TRANS/WP.29/GRSP/2001/15
4 September 2001

World Forum for Harmonization of Vehicle Regulations (WP.29)

PROPOSAL FOR DRAFT 04 SERIES OF AMENDMENTS TO REGULATION No. 16
(Safety-belts)

Transmitted by the Expert from France

The table and the key of letters to be inserted in table, amend to read:

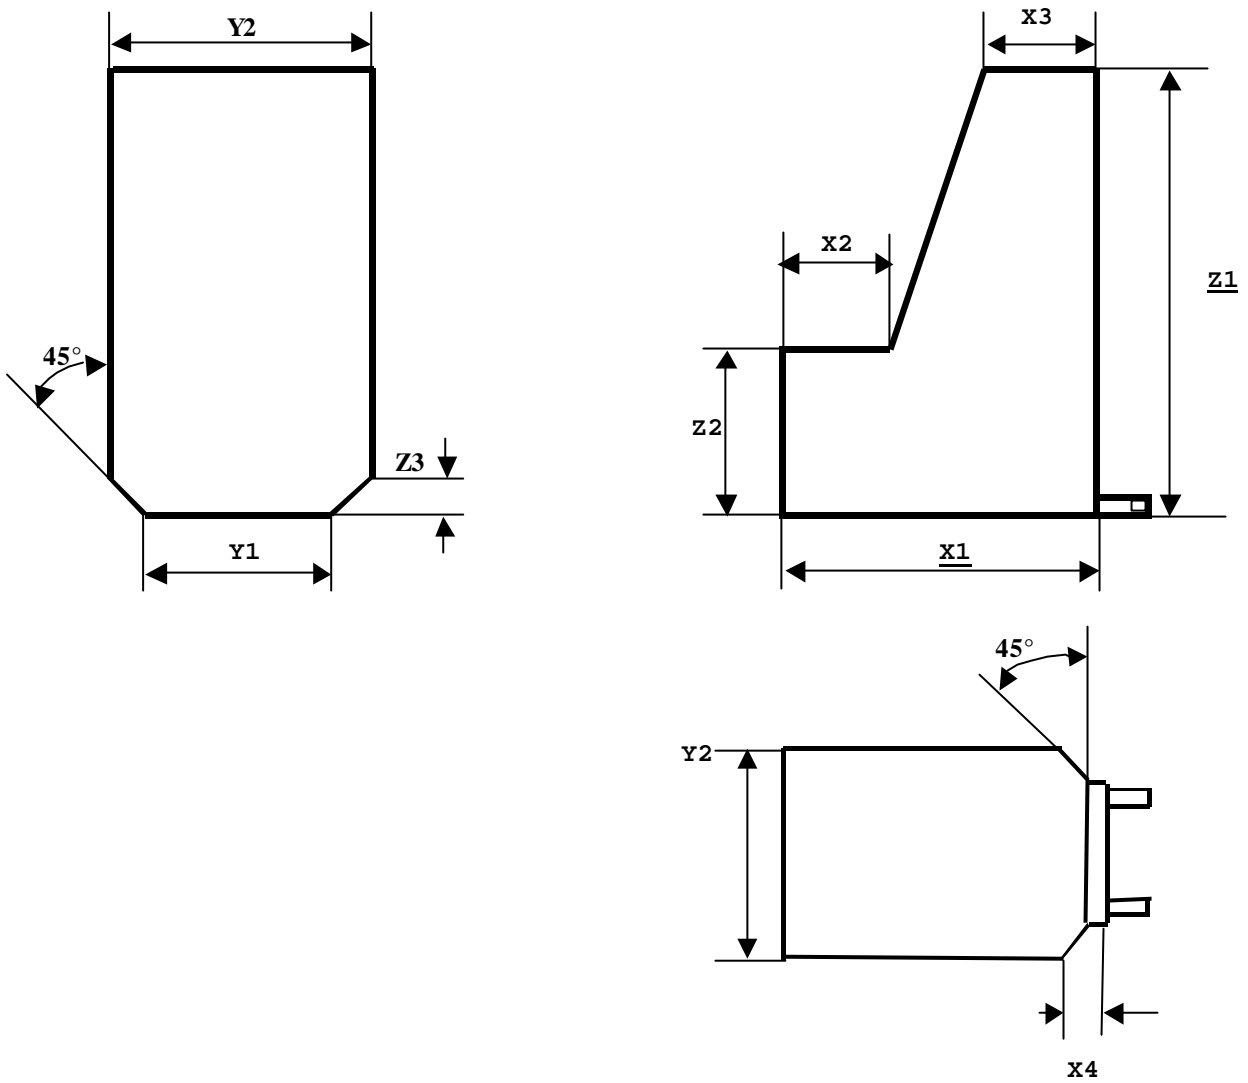
Mass Group	Seating position (or other site)				
	Front Passenger	Rear Outboard	Rear Centre	Intermediate Outboard	Intermediate Centre
0 - up to 10 Kg					
0+ - up to 13 kg					
I - 9 to 18 kg					
II - 15 to 25 kg					
III - 22 to 36 kg

B = Built-in restraint approved for this mass group.

IFF = Suitable for ISOFIX forward facing child restraint systems (see figure 1) for use in this mass group.

IRF = Suitable for ISOFIX rearward facing restraint systems (see figure 2) for use in this mass group.

X = Seat position not suitable ..."

Figure 1: Space required for ISOFIX forward facing child restraint systems (IFF)

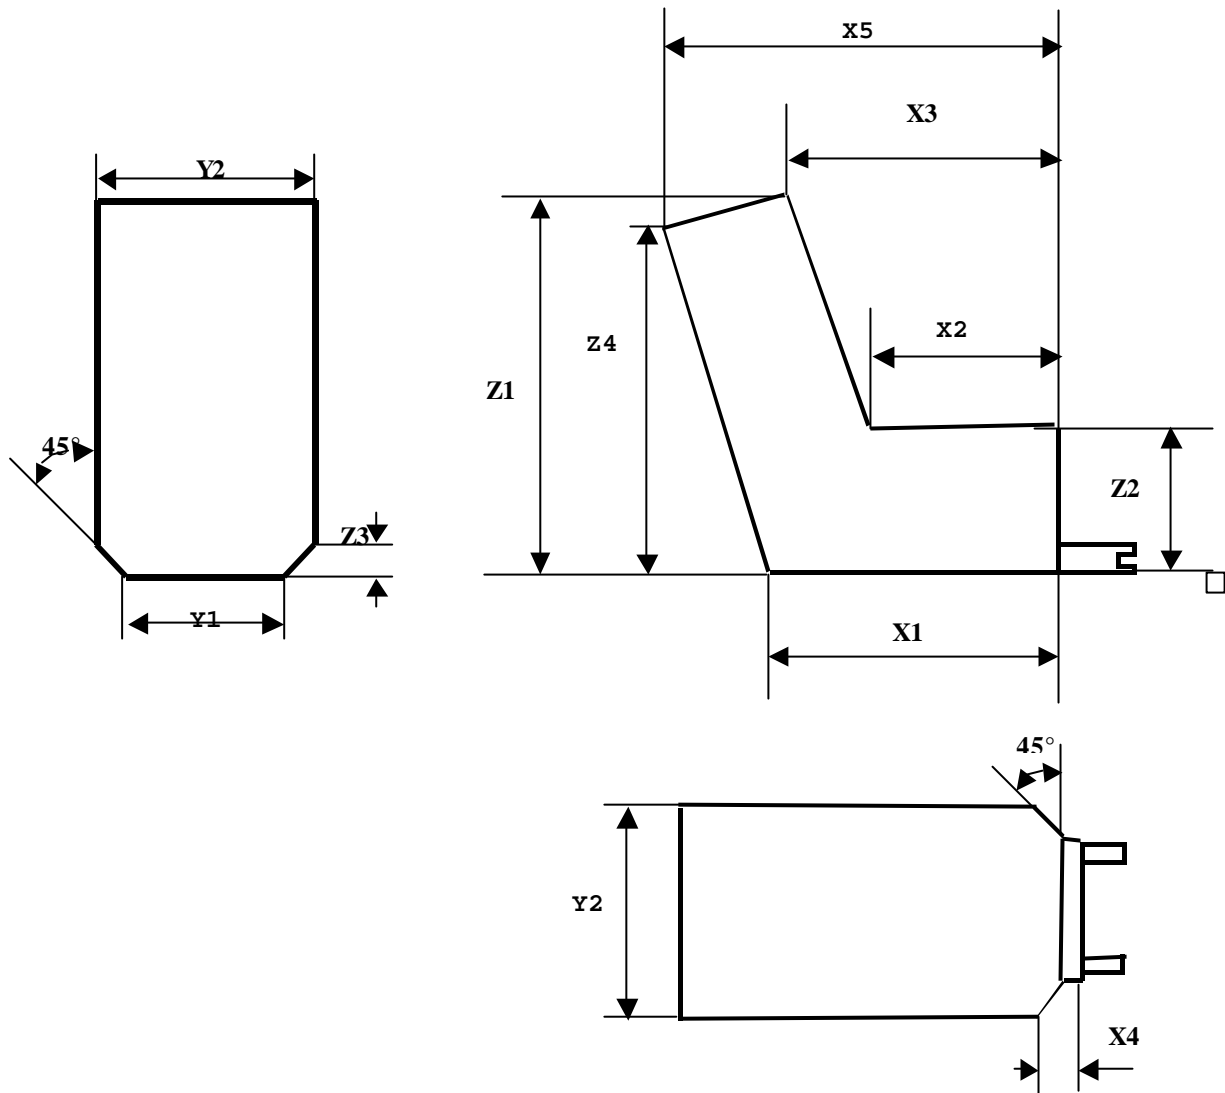
"Insert figures 1 and 2, to read:

Group I	Group II	Group III
X1			
X2			
X3			
X4			
Y1			
Y2	[440 mm]	[440 mm]	[440 mm]
Z1			
Z2			
Z3
